Application for Amendments to the Official Plan for Crystal Beach on Crystal Beach Drive to Terrace Lane

Special Council Meeting 30 June 2025
3856 Terrace Lane and 0-15097 Crystal Beach Drive Public Comment

Figure 1: The development superimposed on the WWTP.

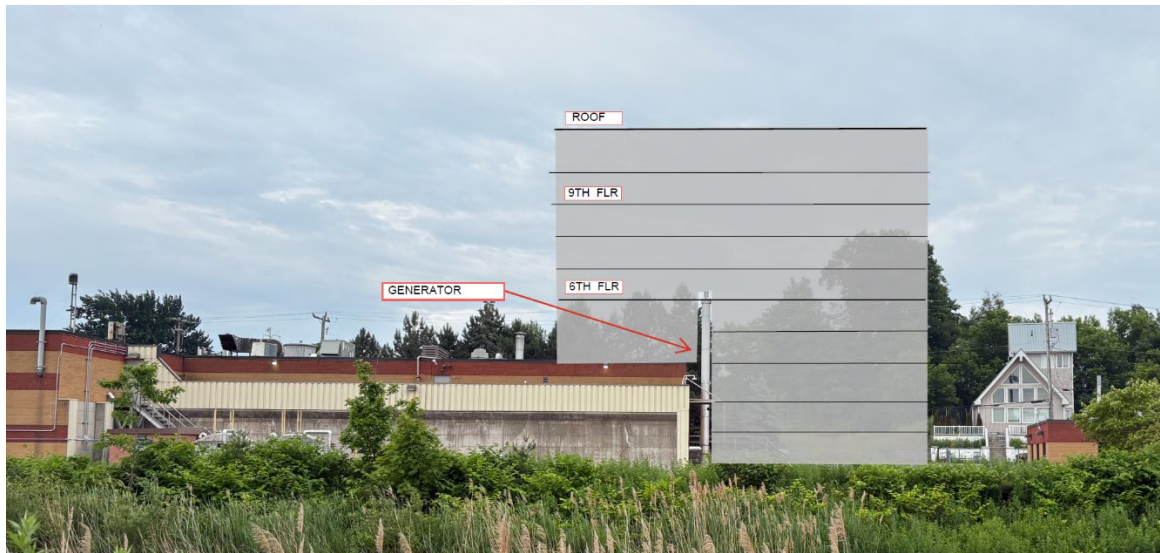
This underrepresents the potential impact. The diesel generator stack is 18 metres above grade at the WWTP, which itself sits approximately 1.5 metres below the proposed building's ground floor elevation. Therefore, the top of the stack would align roughly 16.6 metres above the proposed building's ground floor—approximately at the 6th floor level. As such, residents from the 6th floor upward would qualify as “elevated receptors” and could be exposed to emissions during periodic testing or emergency operation. This exposure warrants a more thorough evaluation than is currently presented.

See Figure 1 below.

The RWDI report's treatment of the WWTP's diesel generator operation is overly simplistic and does not adequately address real-world scenarios. The generator is not merely an emergency backup that operates infrequently—it is tested monthly for one hour and is relied upon during power outages. A notable example occurred during the week-long blackout that began around 3:30 p.m. on December 23, 2022. During that event, the WWTP's emergency generator ran for approximately nine hours before failing due to a fuel shortage. This left the facility inoperable and raised significant concerns about public health and environmental protection.

Figure 2:

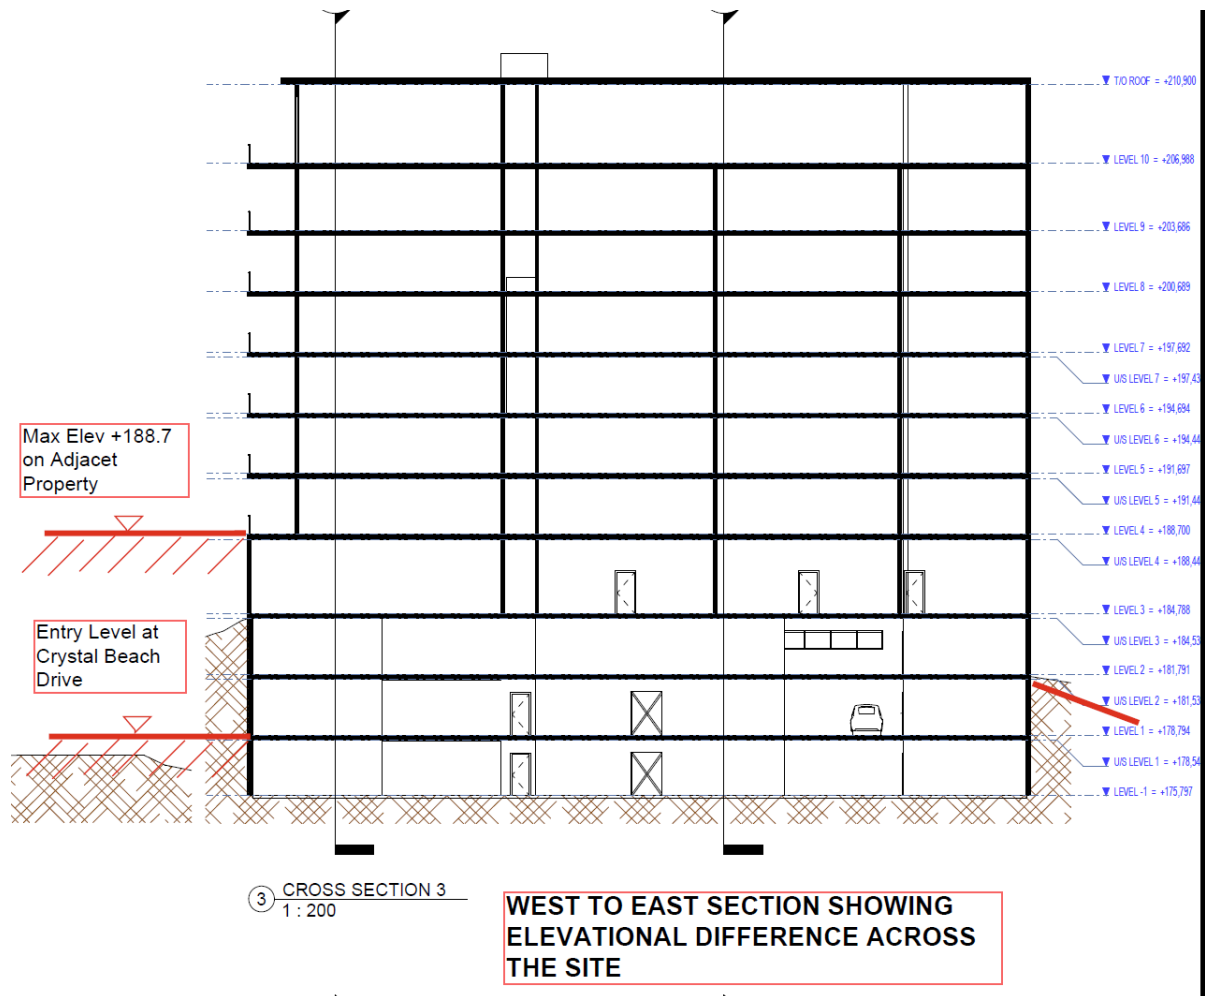
The report recognises that excavations will be to the property lines and that shoring will be required and *"the upper levels of the shoring system would have to be supported by a 'tie-back' arrangement drilled at an angle into the Cherty Limestone rock under the adjacent properties to the east and west and also under the road at Crystal Beach Drive where utilities have to be avoided."* Alternately, should permission for tie-backs be refused by the adjacent property owners then a temporary raker and waler system of shoring within the confines of the property under development will be necessary, but would have to be removed when the concrete floors slabs are completed and have attained their specified strength.

Lateral soil pressure increases with depth so the lateral pressure from the west will be greater than the lateral pressure from the east which act facing each other. Tie-backs resist the lateral forces on each side. In the absence of tie-backs the unequal forces in opposite directions must be resisted by the structure and this would require significant east-west concrete shear walls which are not account for in the floor plans and would impede circulation within the below grade parking level and the first three floors above grade. See Figures 2 and 3 below.

Figure 3: Existing Soil Profile Along West Property Line

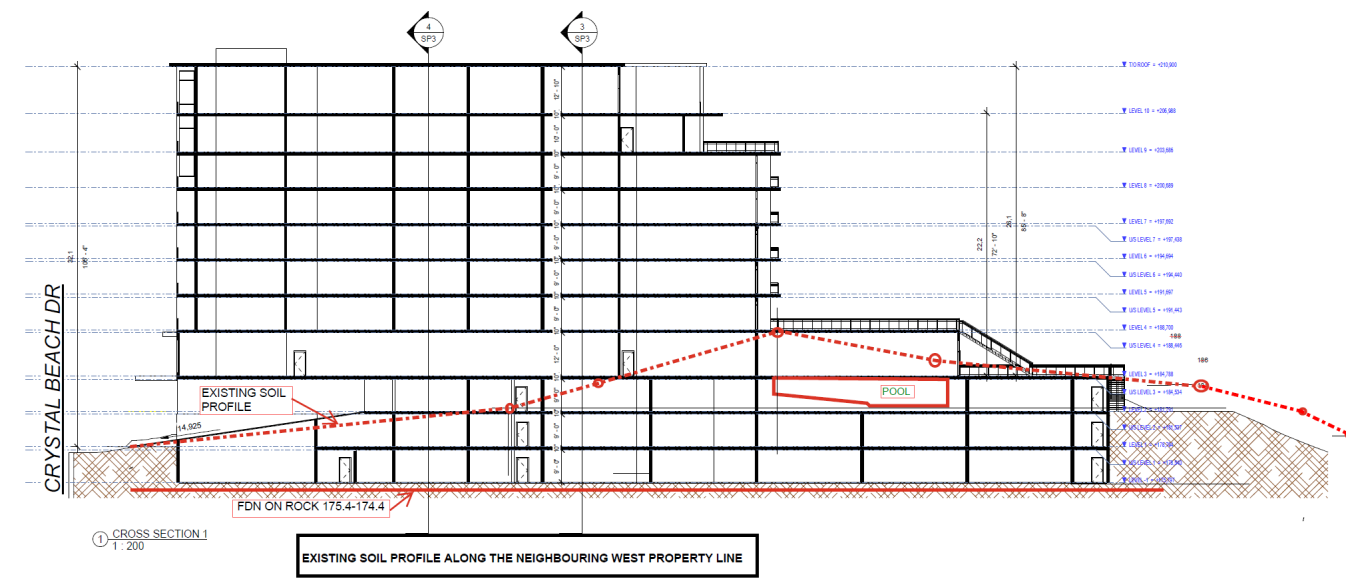
- the need for stabilisation of the sandy soil overlying the rock, and erosion control measures;

- “Unfortunately, because of the lot coverage there will be little vegetative stabilization (usually by planting native grasses, shrubs, and trees) which is a natural and effective way to anchor the soil and reduce surface erosion.”
- “Water management is equally important. Effective drainage systems, such as swales or French drains, help redirect water away from the site, reducing water saturation in the soil. Permeable surfaces and rainwater harvesting systems can further reduce surface runoff that might otherwise contribute to erosion. “
- “Ongoing monitoring and maintenance are essential after construction to ensure the long-term stability of the site.”

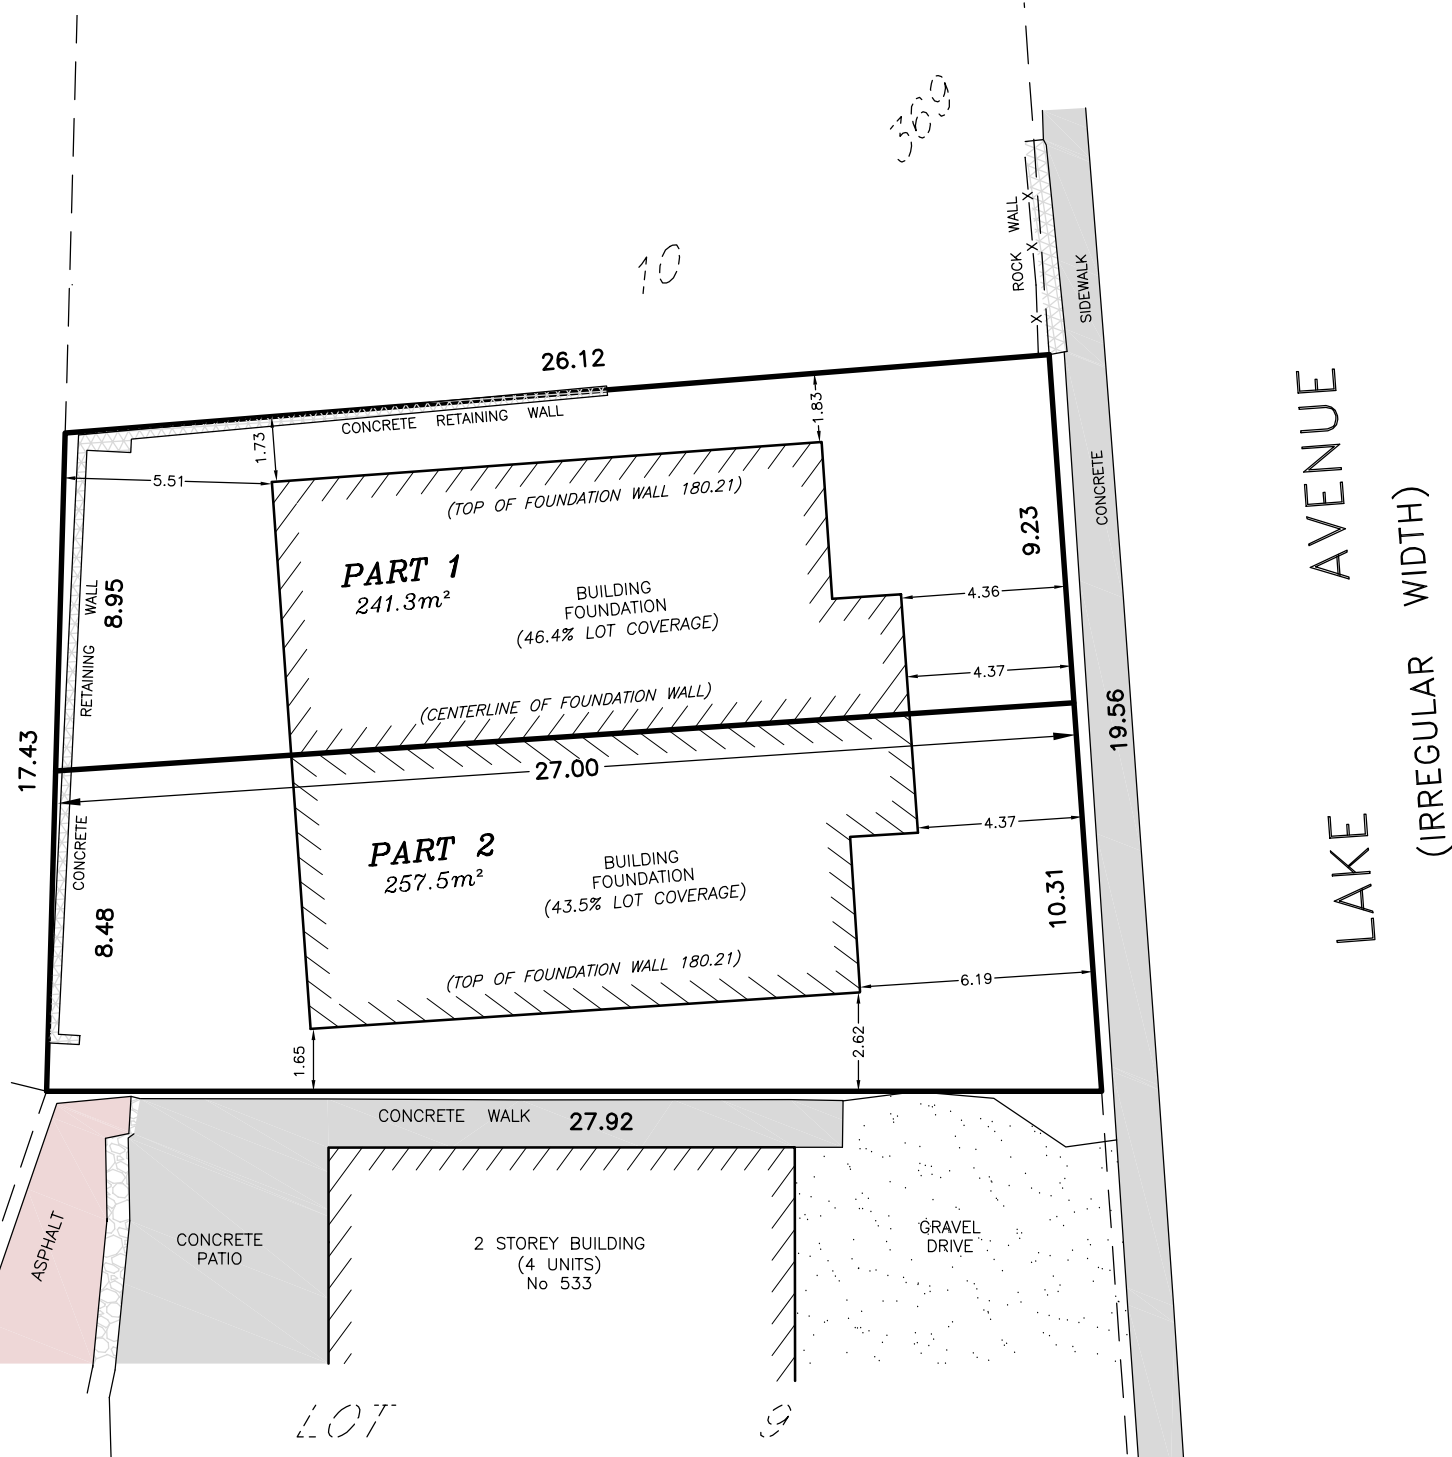
Dune height to ground surface	7.739m (25.39ft)
Dune height to foundation slab	13.56m (44.49ft)
Height at fence to ground surface	6.379m (20.987ft)
Height at fence to floor slab	12.2m (40m)

**The 0.9m setback isn't wide enough for a swale and retaining wall
Removing the sand dune will adversely impact the adjacent residential lots**
